# Brown & Root Environmental

Subject: Submittal of Responses to RIDEM Comments dated May 29, 1997

**Responses to The Second Group Comments From the  
Rhode Island Department of Environmental Management on the  
Draft Site Assessment Screening Evaluation Report (SASE)  
Former Robert E. Derecktor Shipyard,  
NETC Newport, Rhode Island  
Received on May 30, 1997**

FIGURE 3:

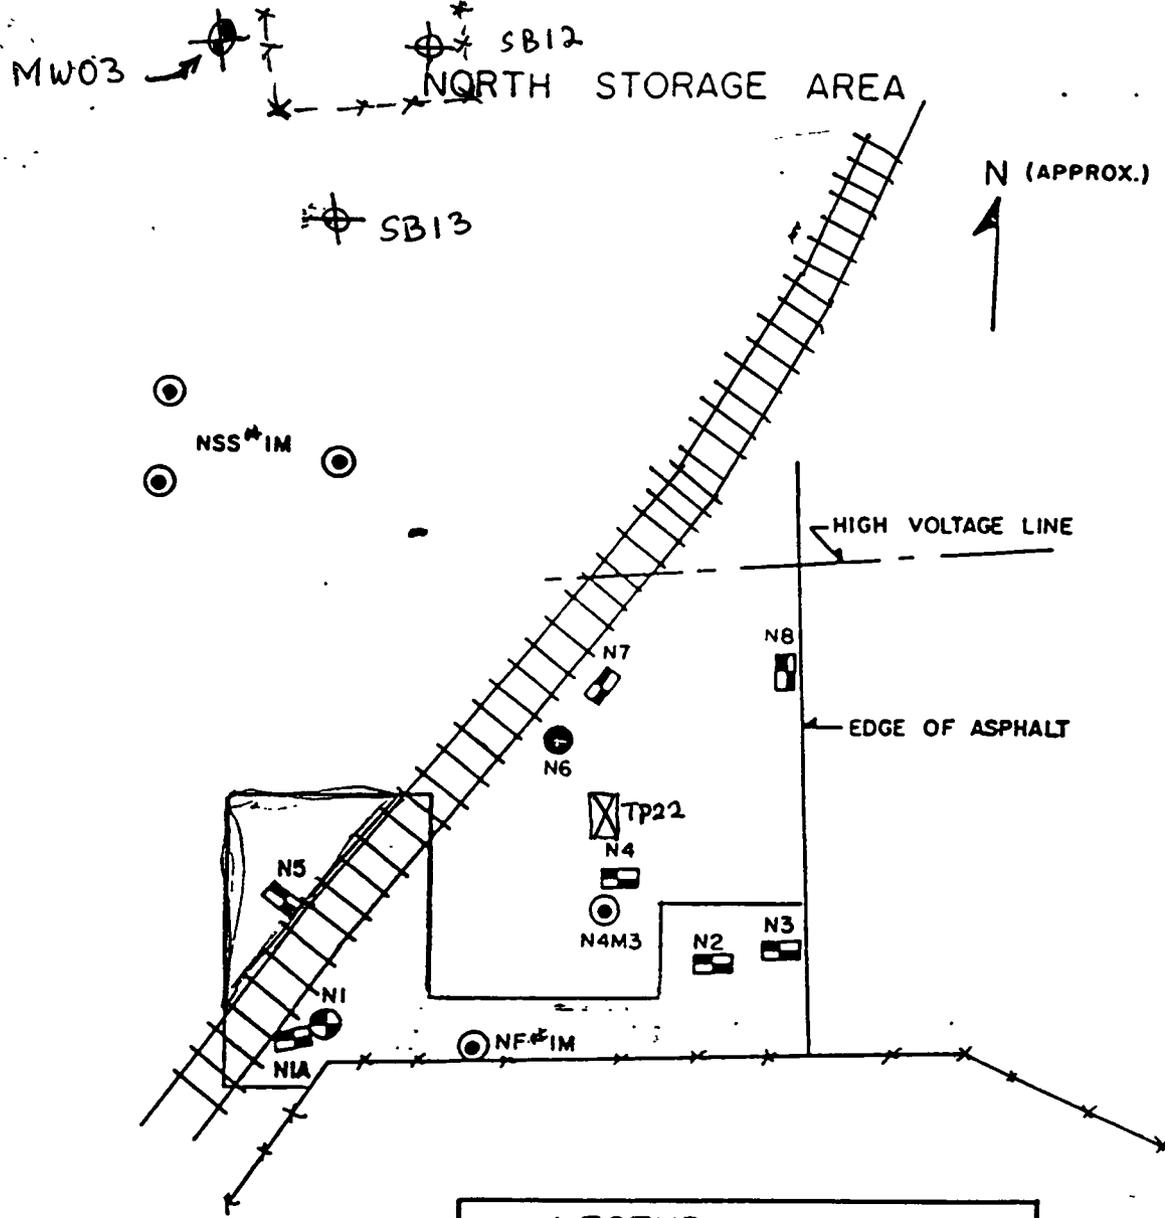
The Navy has indicated that the exact location of the samples in question is not available, therefore the Navy is unable to comply with the Office request to depict the historic sampling locations in question on a map with the current sample locations. The 1984 study includes two figures drawn to scale depicting the sampling locations, therefore it is possible to address this Office's request. The Office reiterates its request that the Navy provide a copy of the original drawing and transpose the requested information onto a map.

*Regarding the historic conditions of the site, the reviewer is asked to refer to the response to Comment No. 1. The map in question has been attached to this response letter. It shows the location of test pits, borings and monitoring wells as located to the best of our ability considering the lack of existing benchmark features on the site.*

*This figure shows that the sample stations that were selected during the development of the work plan and used during the field work are appropriate for the determination of conditions of the subsurface based on the previous records of the site.*
